Revision	Description	Date
A	Initial Release	?
B	As built changes: E990211-00-C	5/99
C	1. Added compensation networks to coil drivers with capacitors, Cadd1 through Cadd10 and resistors Radd1 through Radd5 2. Changed coil driver 183 ohm (R202, R216, R229, R243, R256) to 125 ohm, 2 Watt for ITMX and ITMY and to 183 ohm 1 watt on all other chassis. 3. Cadd1 through Cadd14 added to board to stabilize and limit high freq gain of 1Hz zero, 40Hz pole compensation stage. 4. Dadd1 through Dadd20 added to coil driver for op amp input protection.	2/00
D	Added Radd6, Radd7, Radd8, Radd9 to terminate unused inputs of MAX333 switches per E010178-00.	10/01
D1	Removed two stages of chebychev filter for each degree of freedom per E010181-00.	10/01
D2	Added note (sheet 1) about replacement of input matrix MAX509s with fixed resistors per E010184-00.	10/01

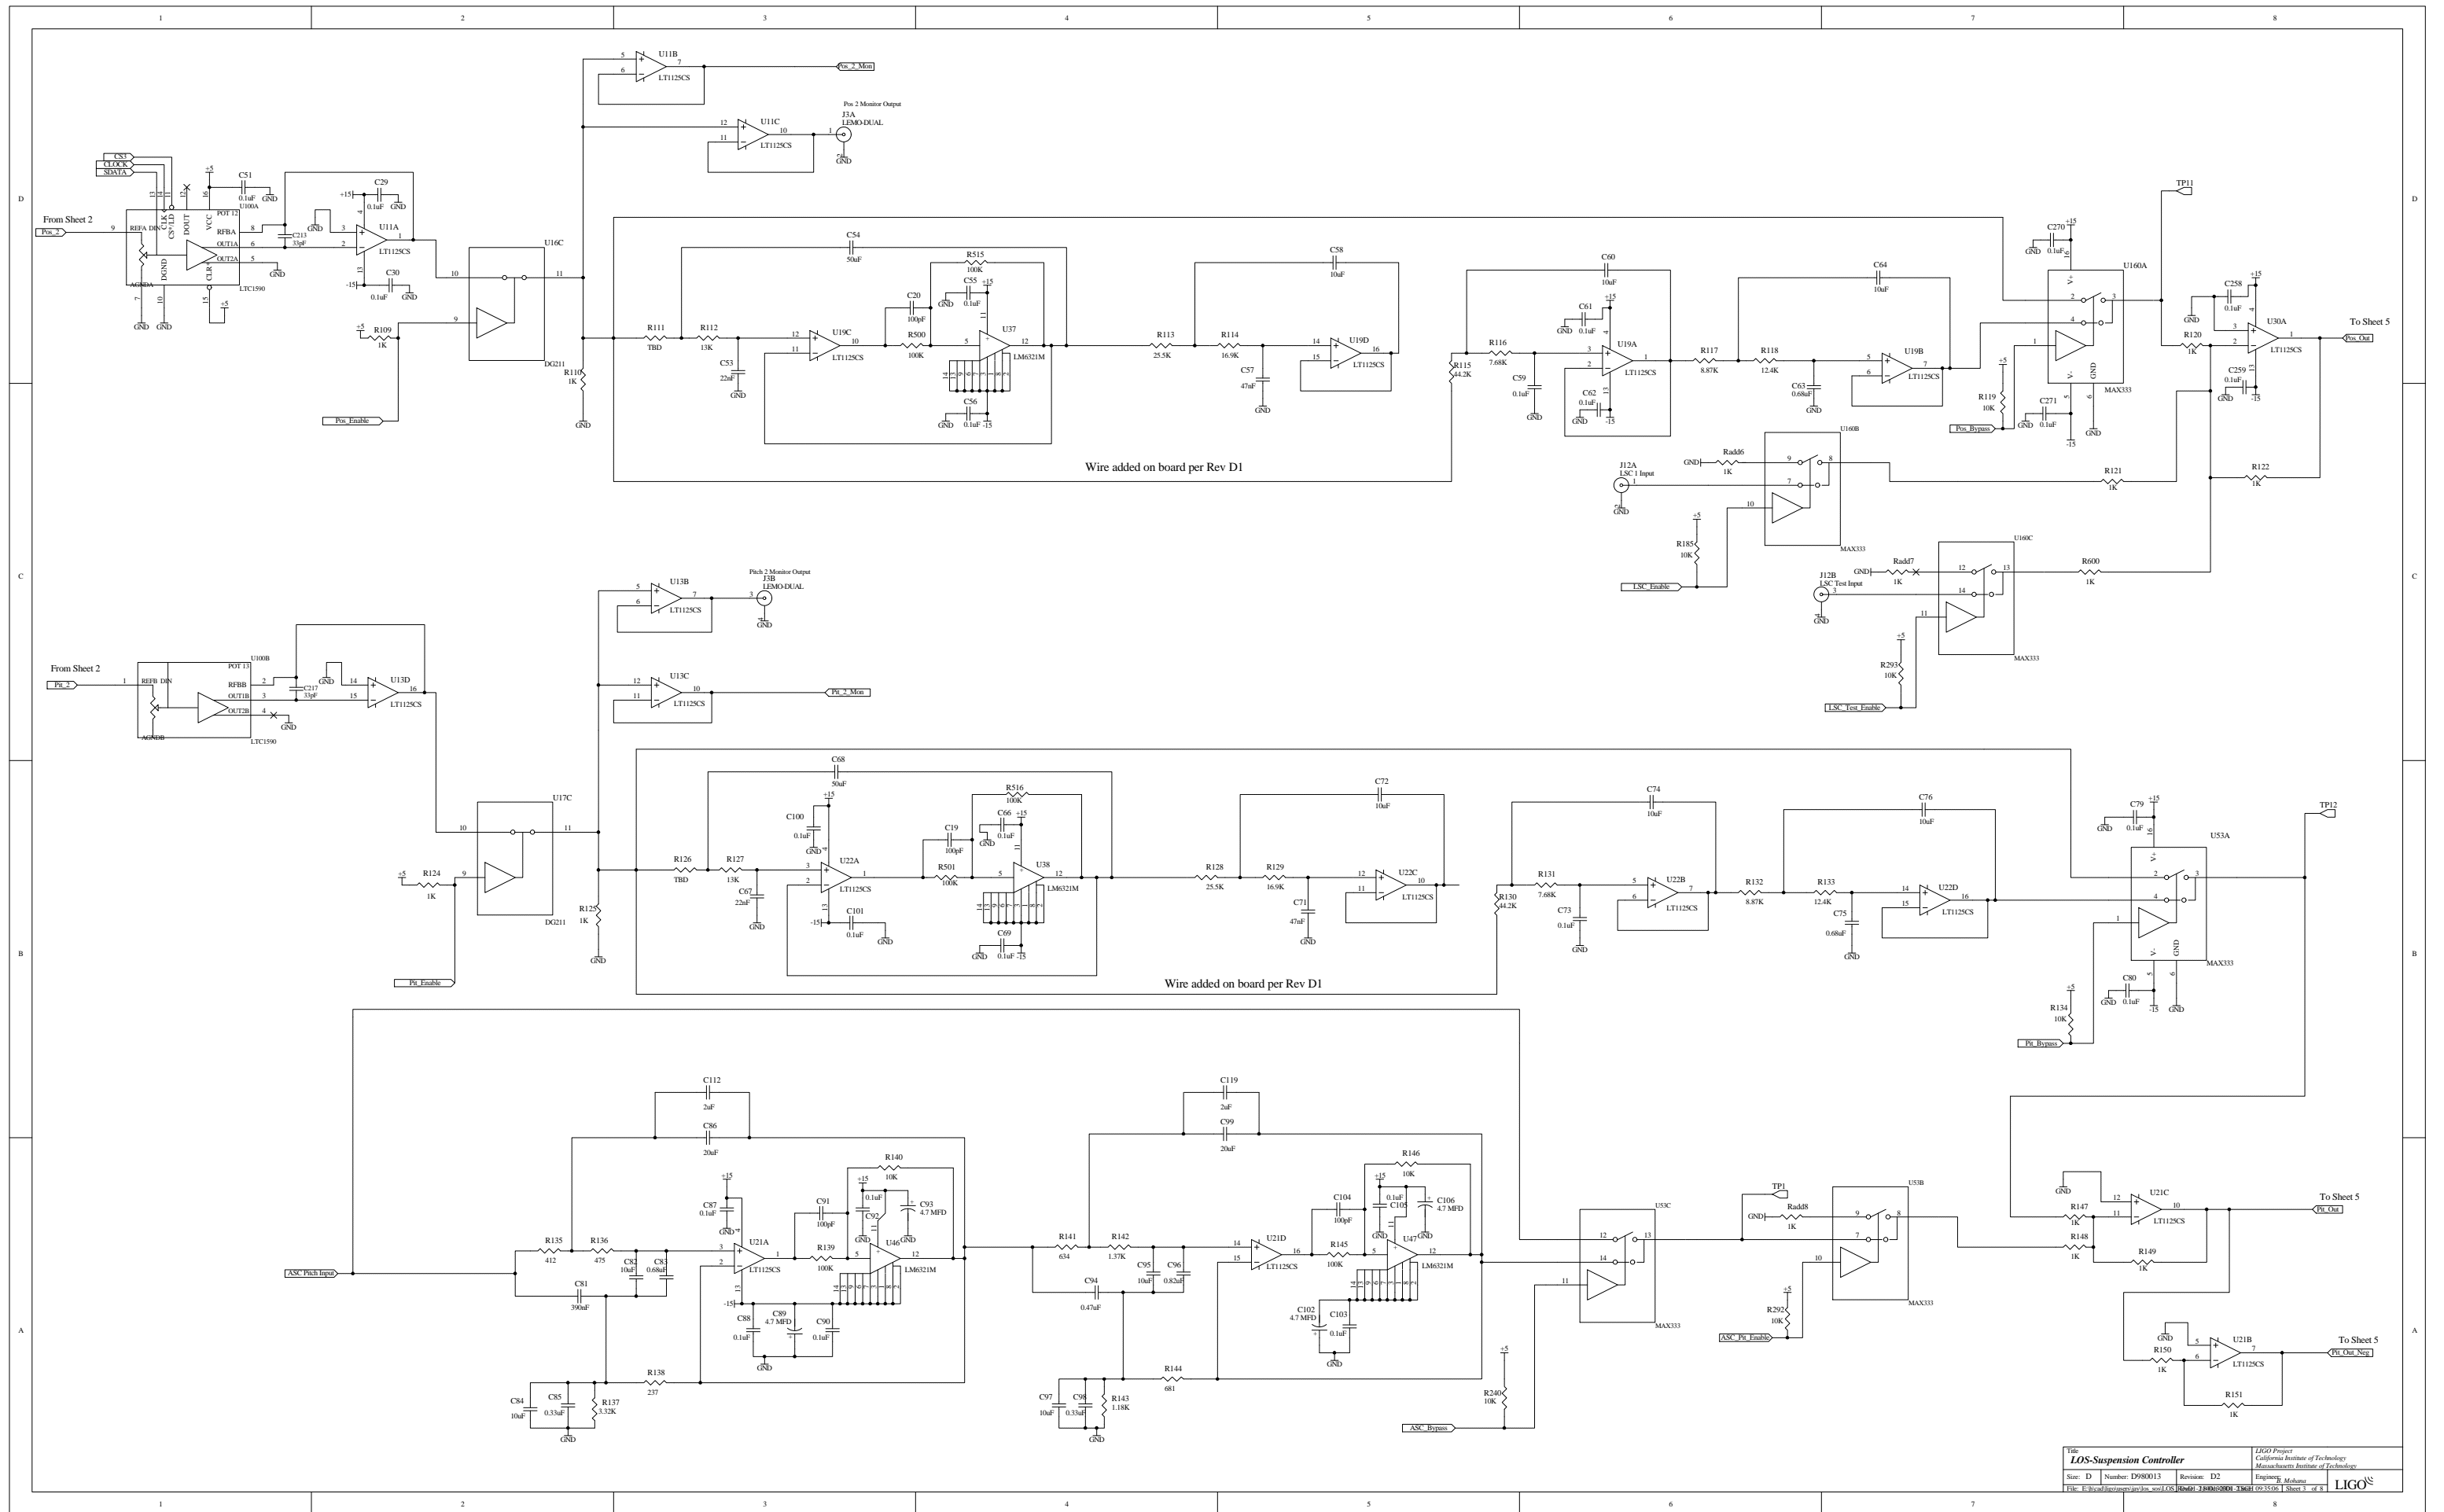
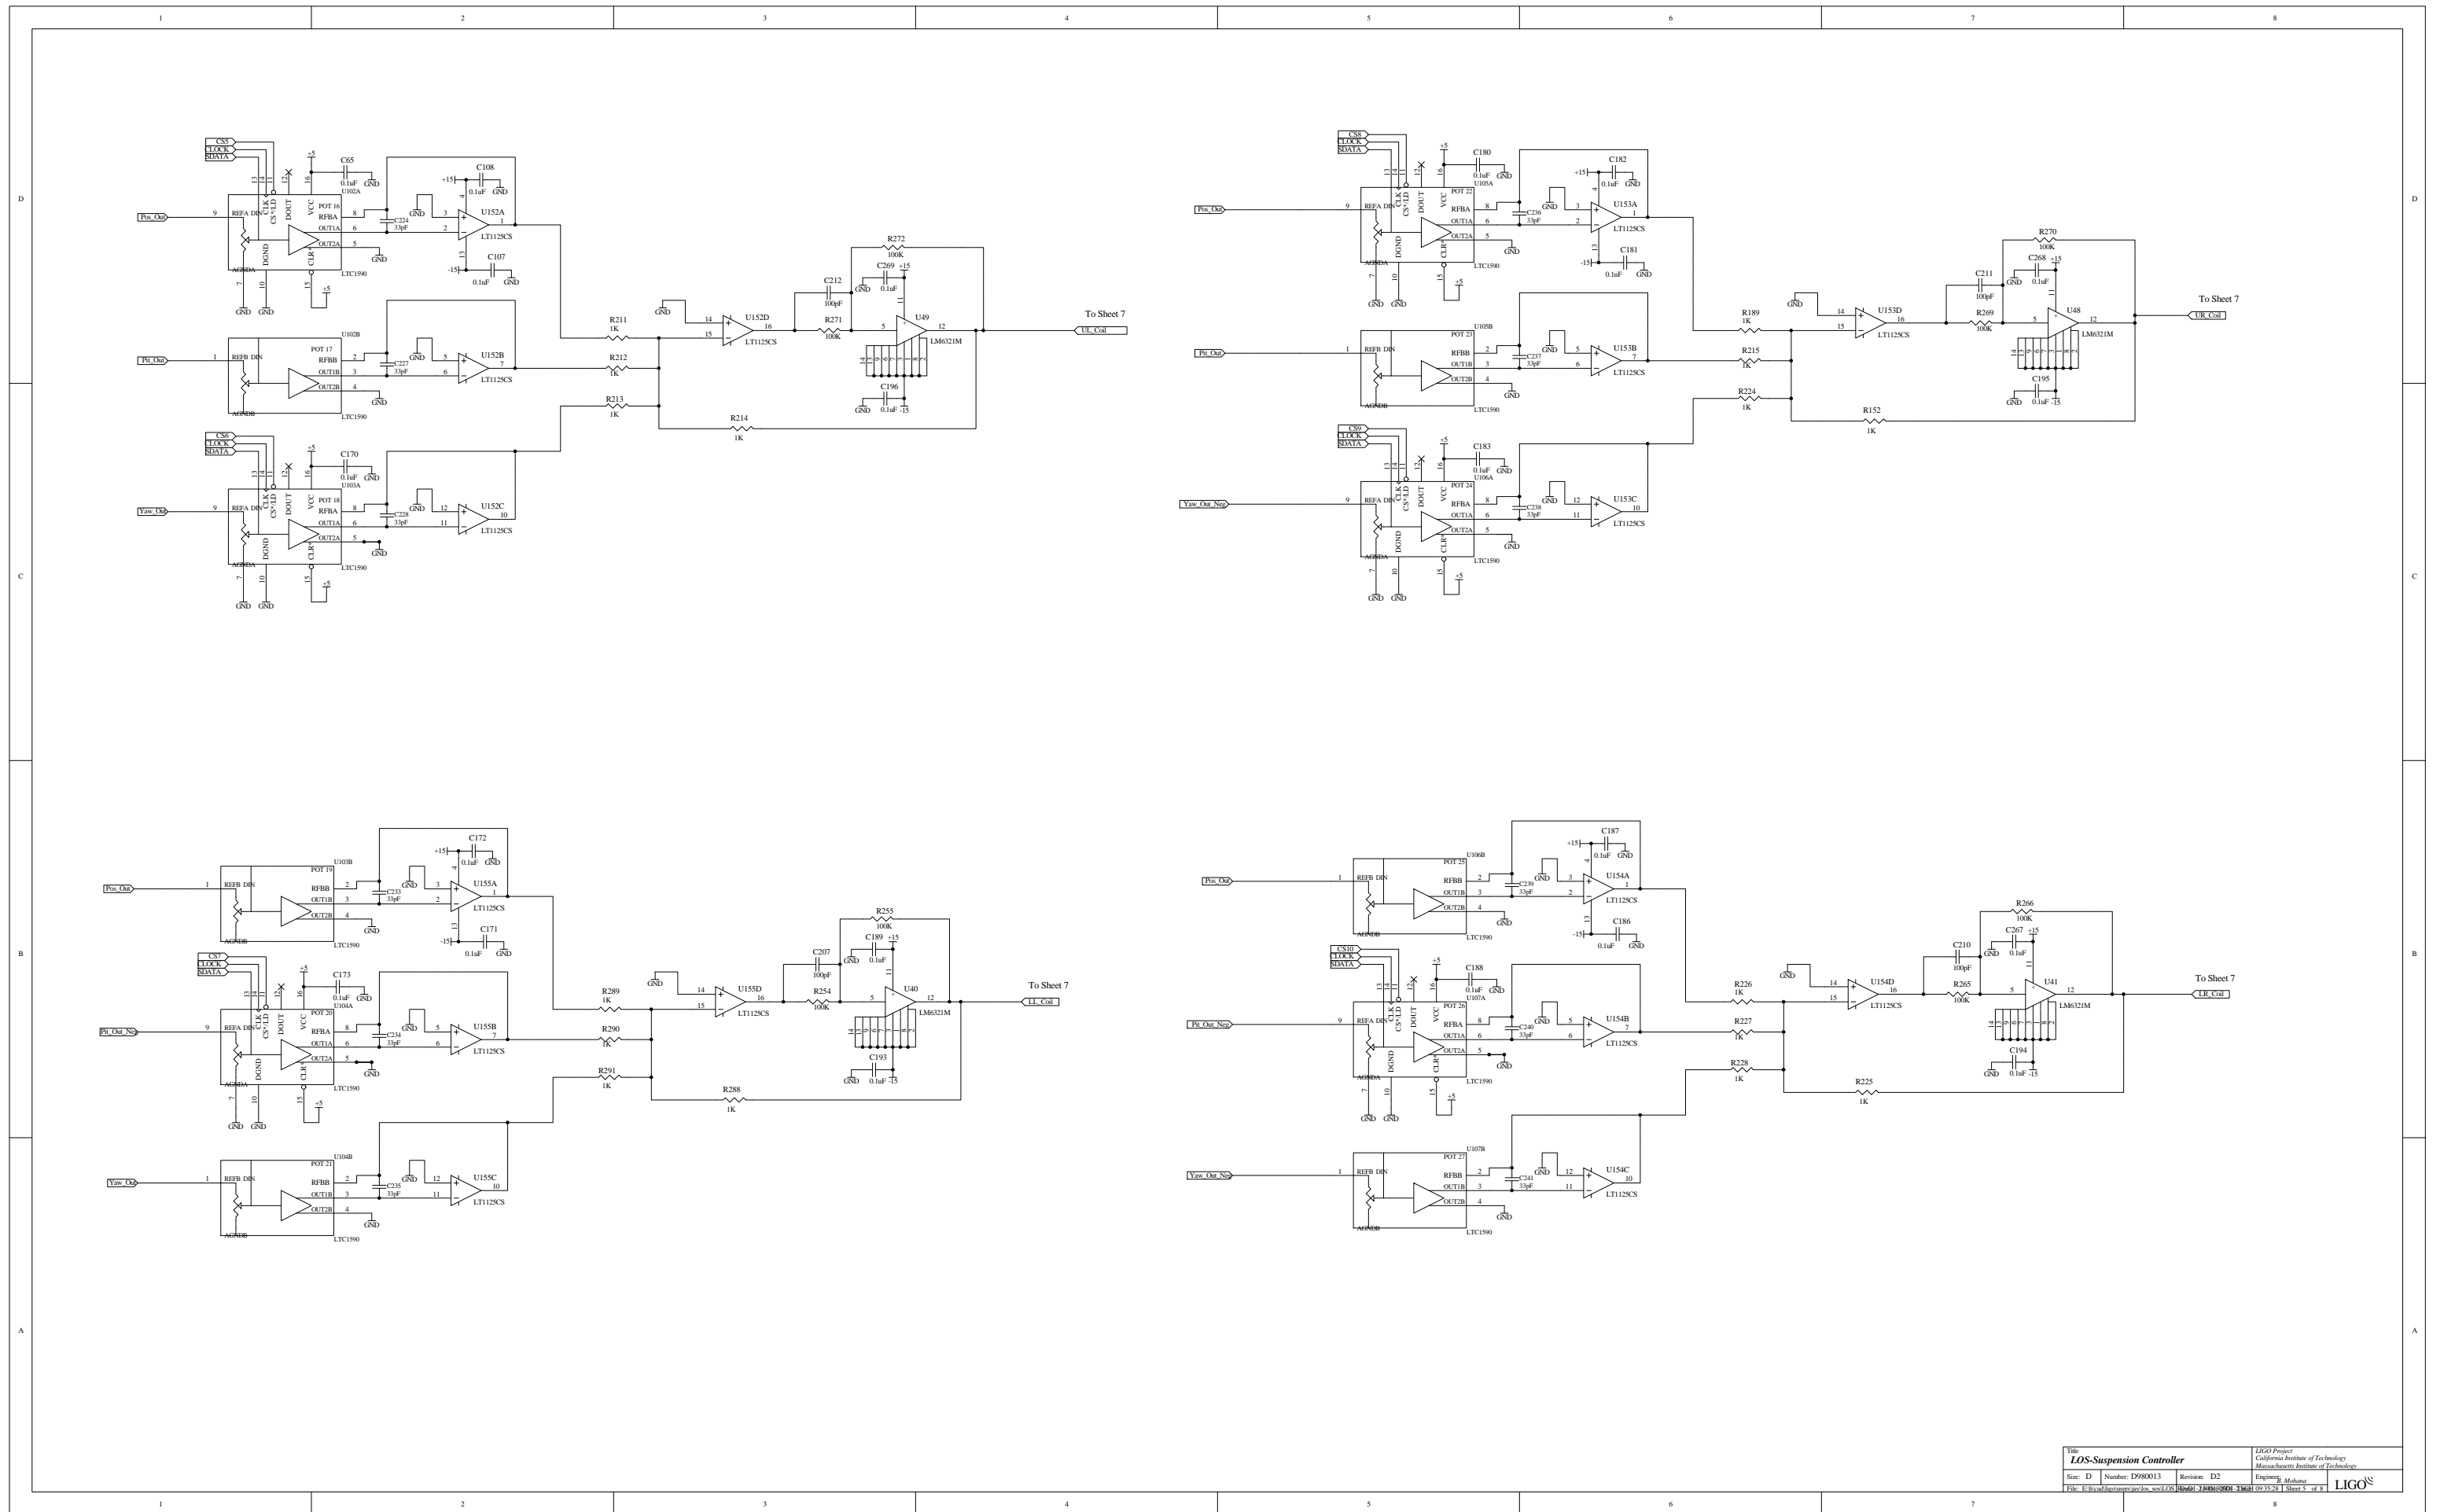
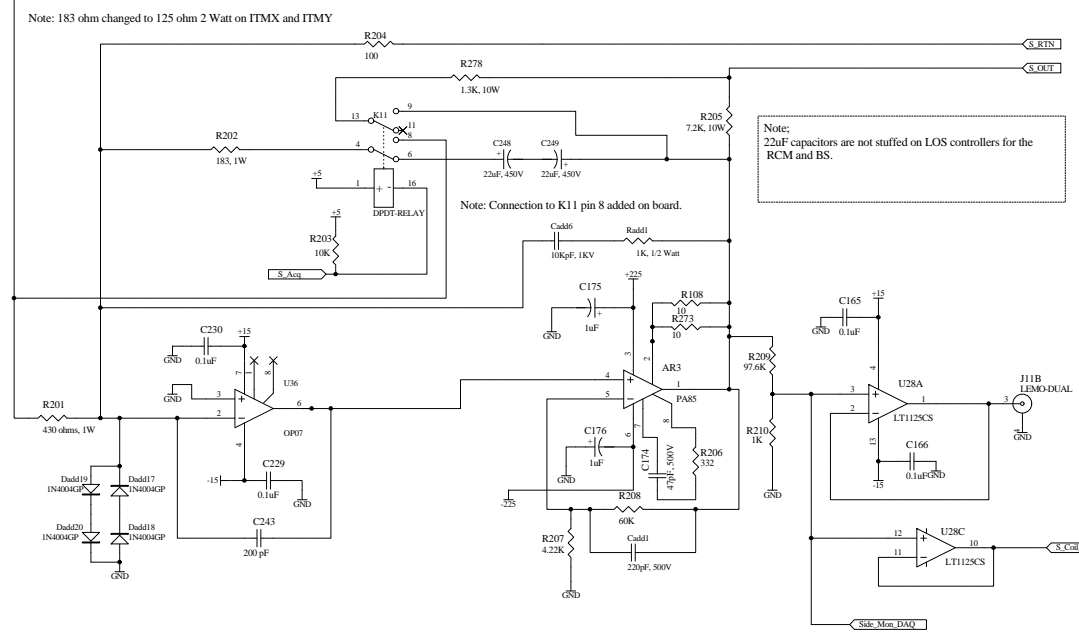
Note:
402 ohm resistor and 10uF capacitor are not stuffed on LOS controllers for the RCM and BS or any optic that is always run in the acquire mode.

Note:
402 ohm resistor and 10uF capacitor are not stuffed on LOS controllers for the RCM and BS or any optic that is always run in the acquire mode.

Note: PA85 feedback Cap and resistor added on bottom of board
